TYPE	YEAR	PROJECT NO.	SHEET NO.
CONST.	2018	33002-4177-04	11

STATE OF TENNESSEE
DEPARTMENT OF
TRANSPORTATION

EROSION PREVENTION & SEDIMENT CONTROL (EPSC) PLANS

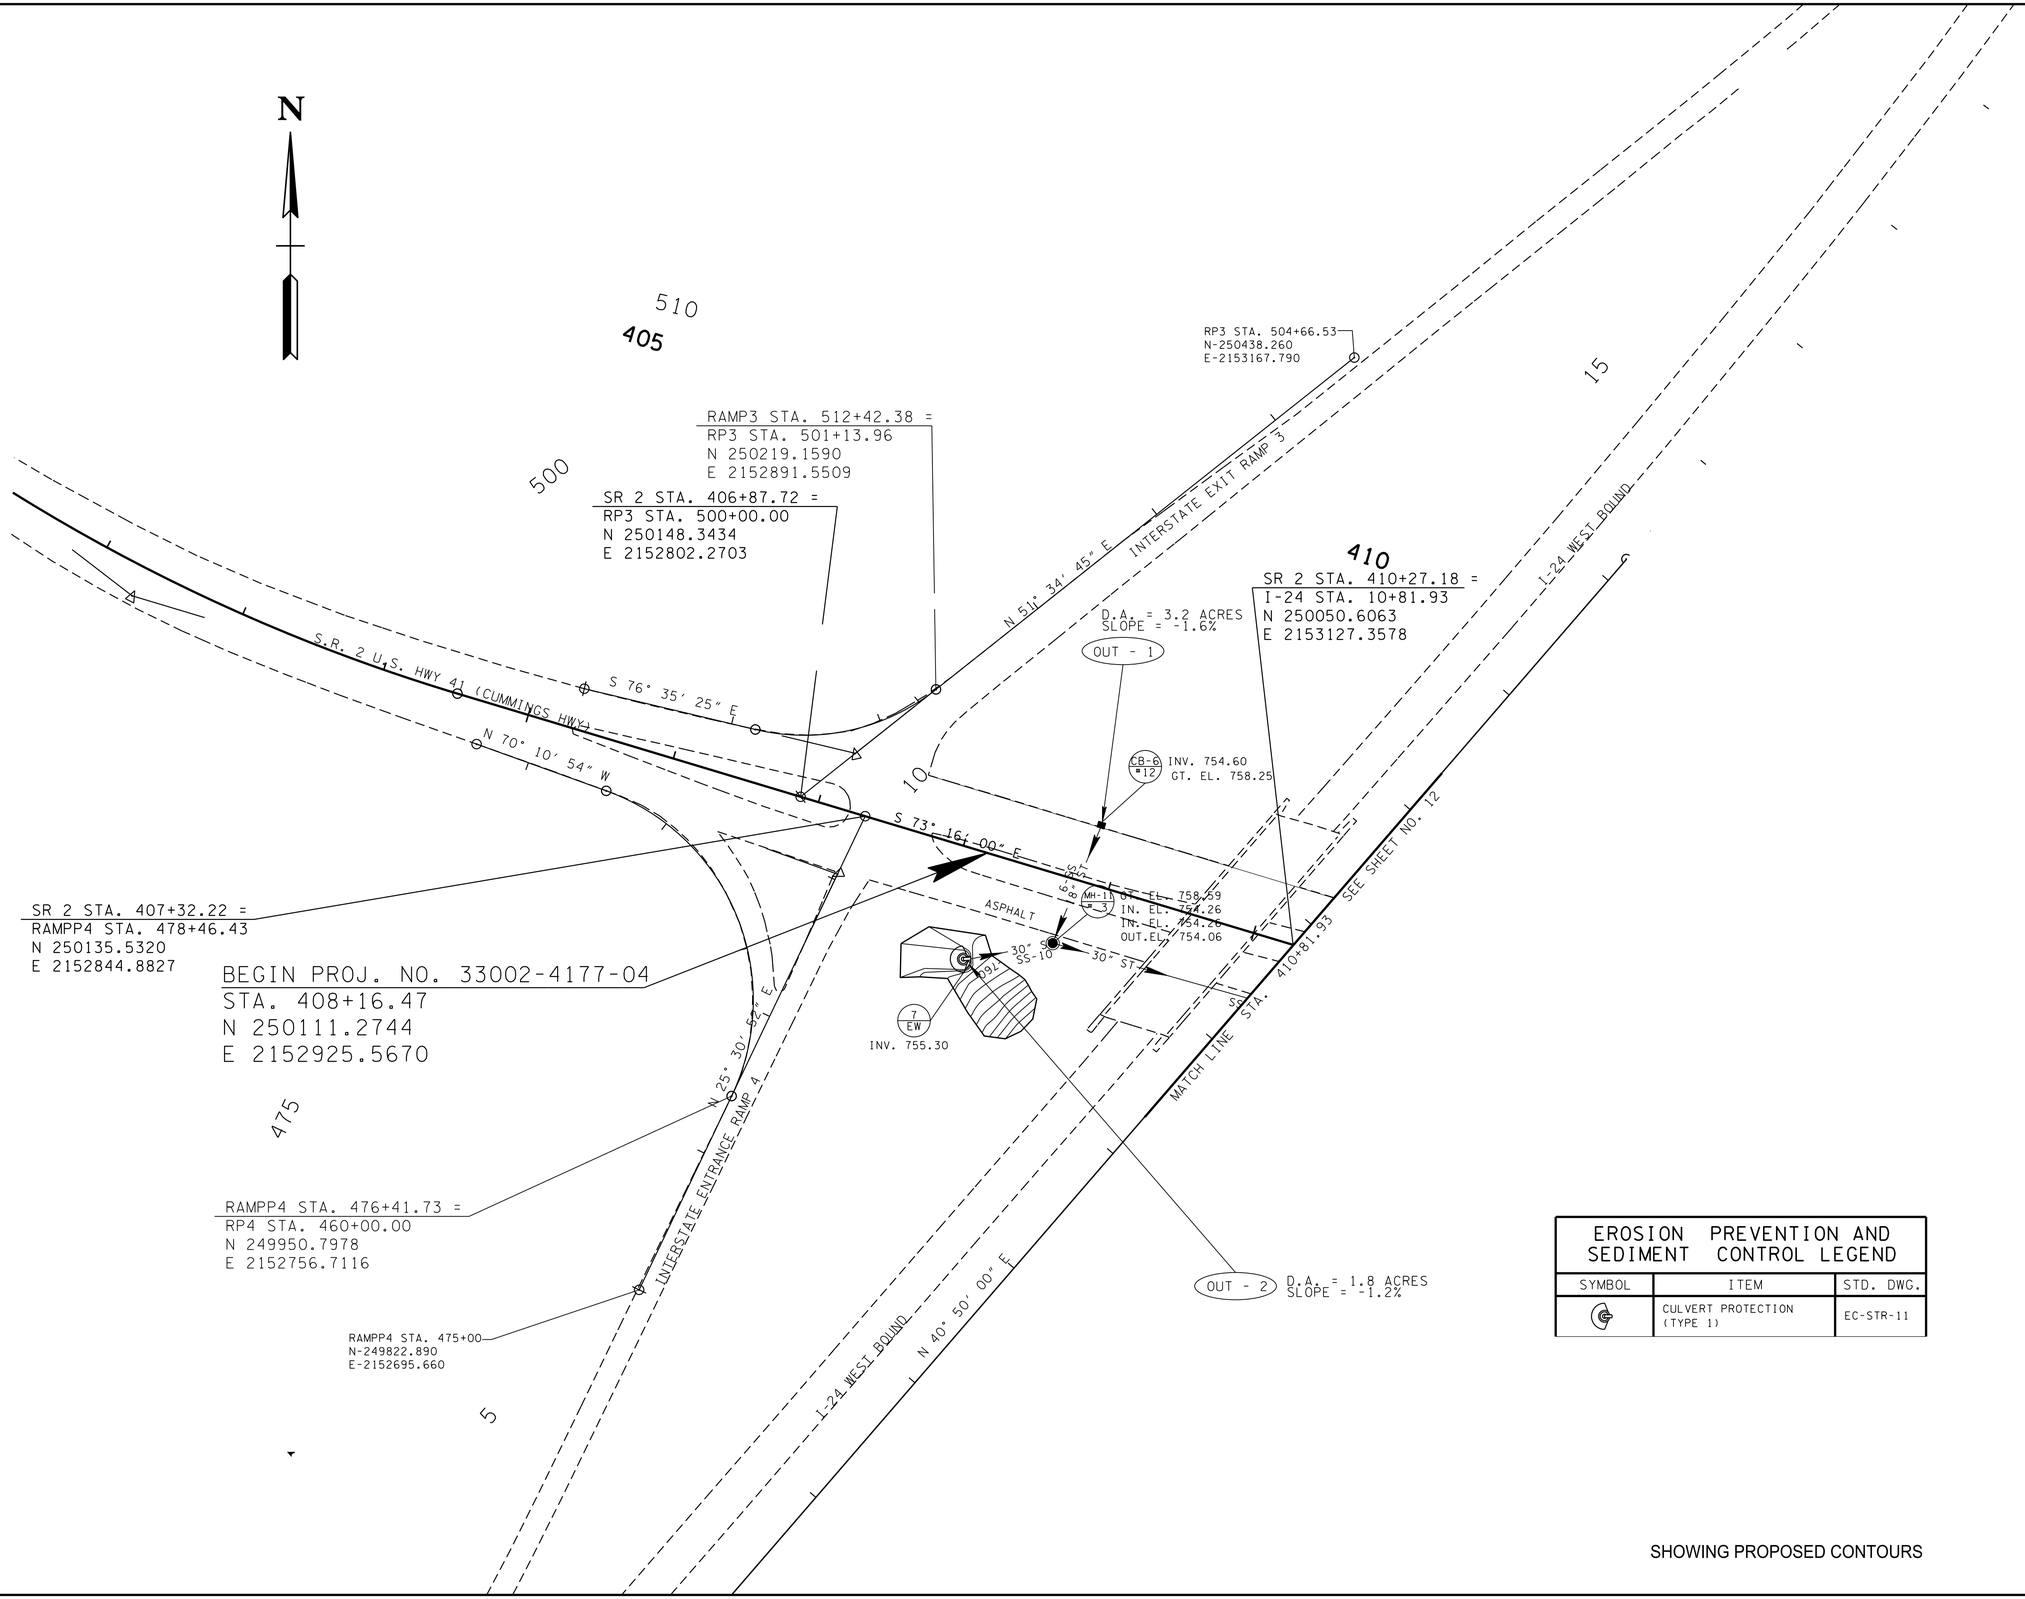
REV. 10-24-18: MH-11 AND EW-7 STA. AND OFFSETS WERE REVISED. SS-10 LOCATION AND LENGTH WAS REVISED. CULVERT PROTECTION (TYPE 1) WAS MOVED TO NEW EW-7 LOCATION. PROPOSED CONTOURS WERE REVISED.
